# MEMORANDUM

Re: Requested design and material changes for the Ninth West Townhomes Planned Development and Preliminary Subdivision Plat Petitions PLNSUB2018-00059 & PLNSUB2018-00223

**ATTACHMENT A: REVISIONS REQUESTED BY THE  
PLANNING COMMISSION**

# NINTH WEST TOWNHOMES

**FRONT ELEVATION**

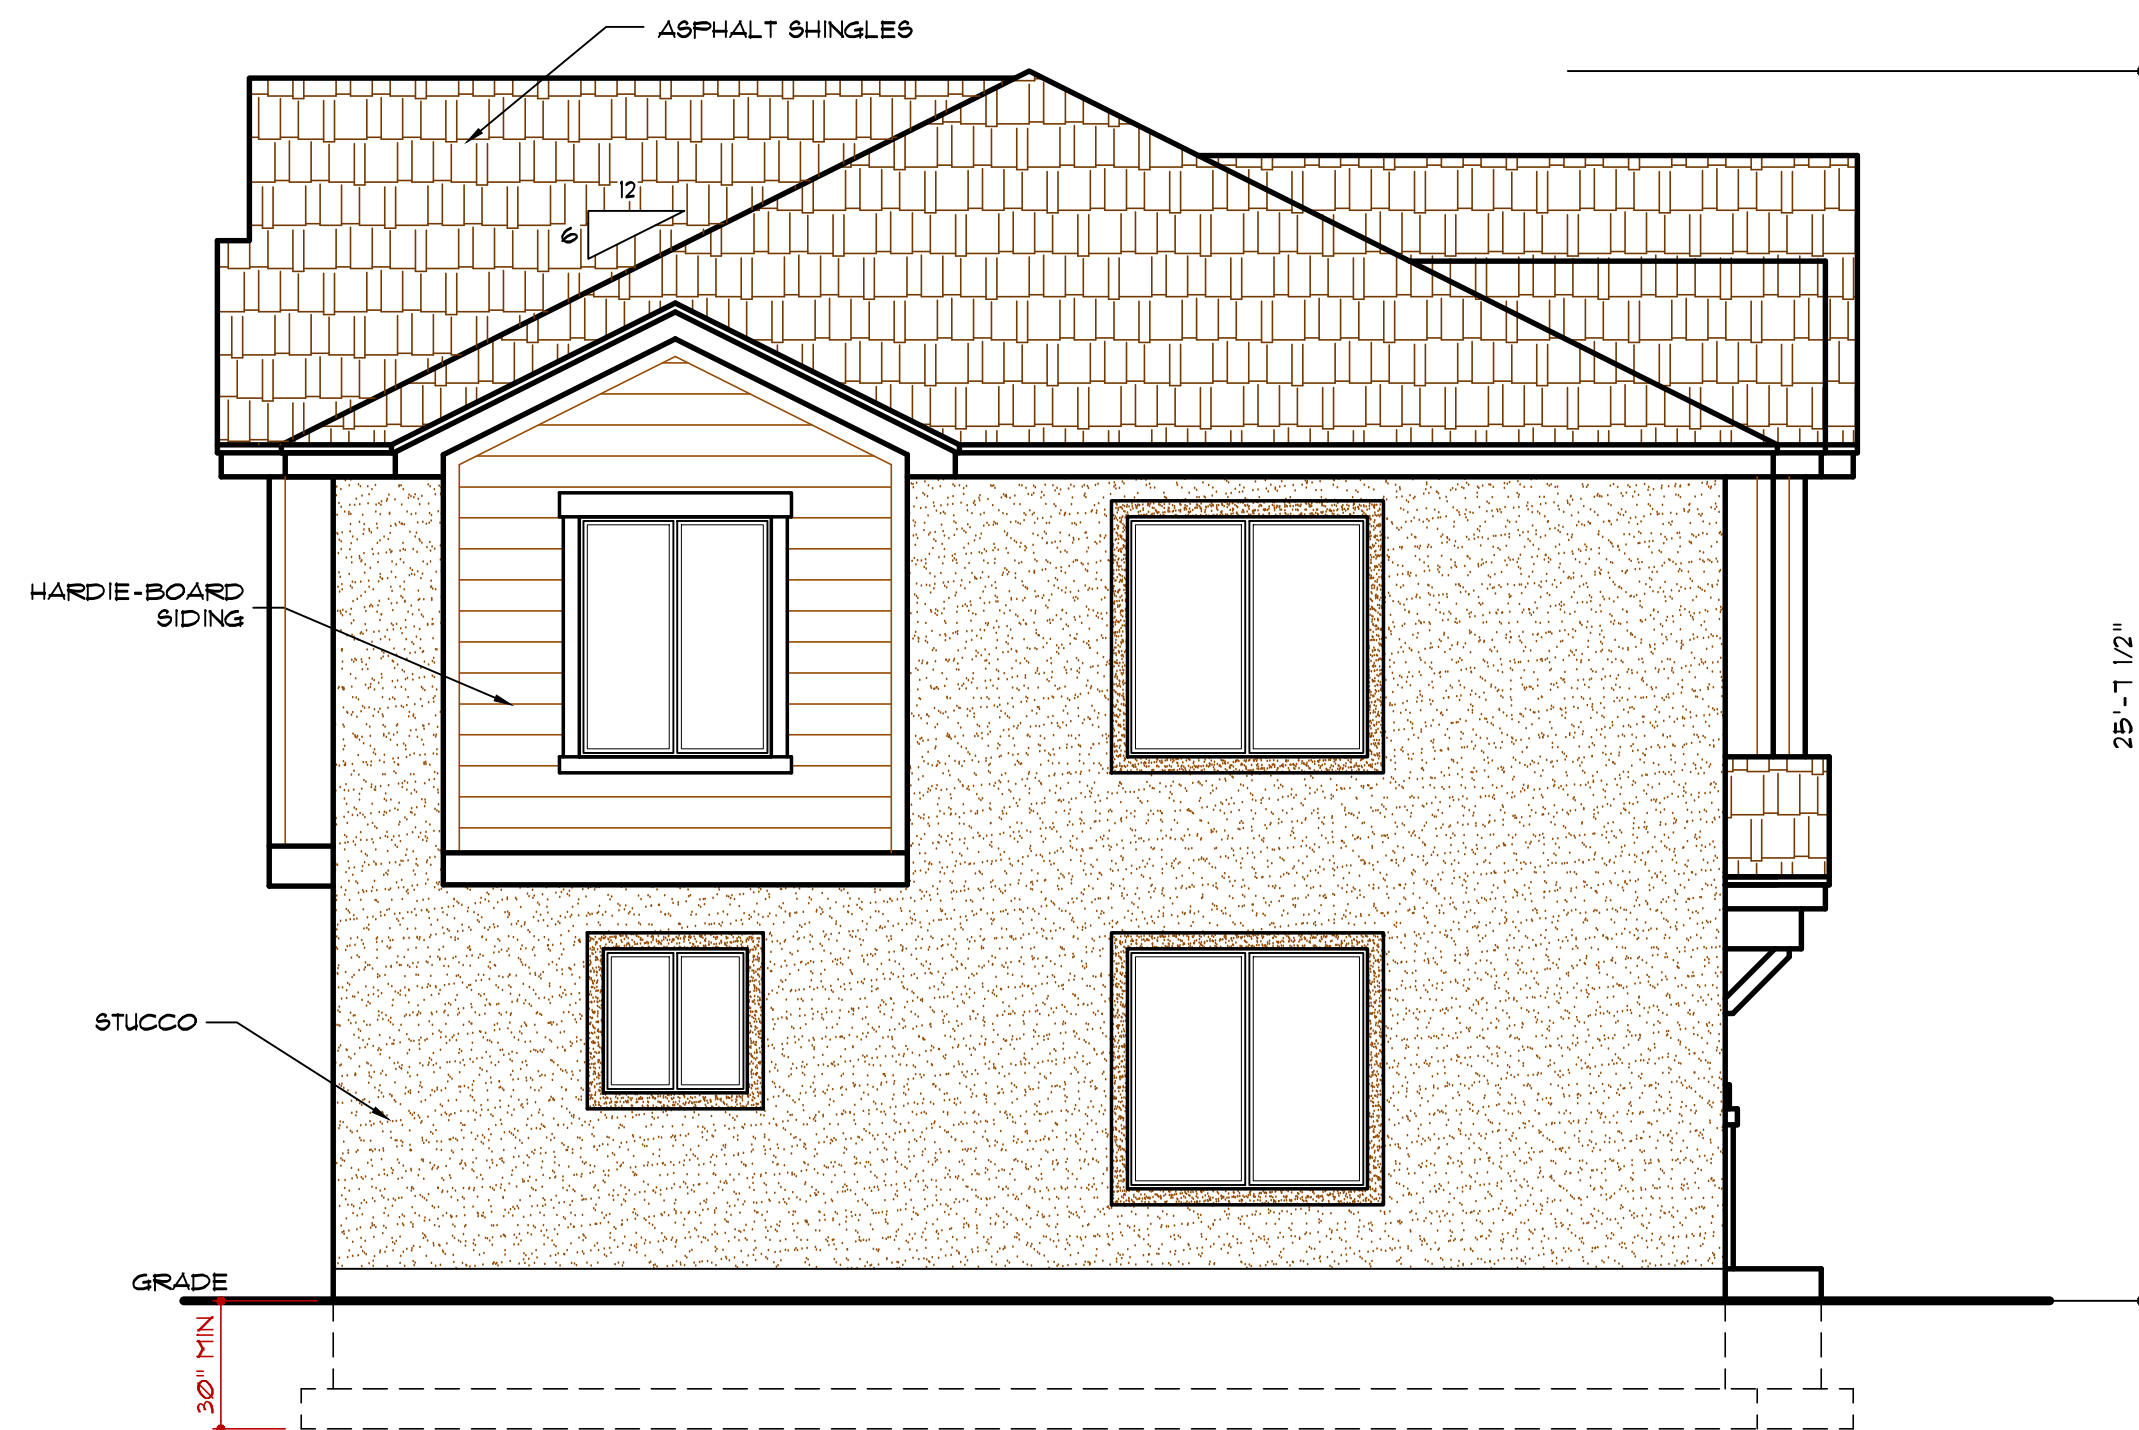
1. Delineate each unit with alternating materials along the northern elevation;
2. Move the front door to unit one closer to the center of the eastern elevation;
3. Add a front porch element;
4. Windows should reflect a residential design.

Northern Elevation: The applicant revised the northern elevation to address the concerns regarding the use of stucco. The revised northern elevation illustrates the use of hardie-board siding, cultured stone and a gable roofed feature on the third unit.

Front Door: Additionally, the front door has been moved to the center of the eastern elevation. The two windows have been placed on either side of the entry.

Porch Element: The applicant explored the front porch options for the proposed development. The applicant could not revise unit 1 to accommodate a front porch element. In lieu of a front porch, the applicant provided a revised eastern elevation to include a porch on grade element. An iteration including on grade flatwork in the front yard and an iteration without the on grade flat work are attached to this memo.

Residential Windows: The east facing windows, which have not altered in style, flank each side of the entry way.
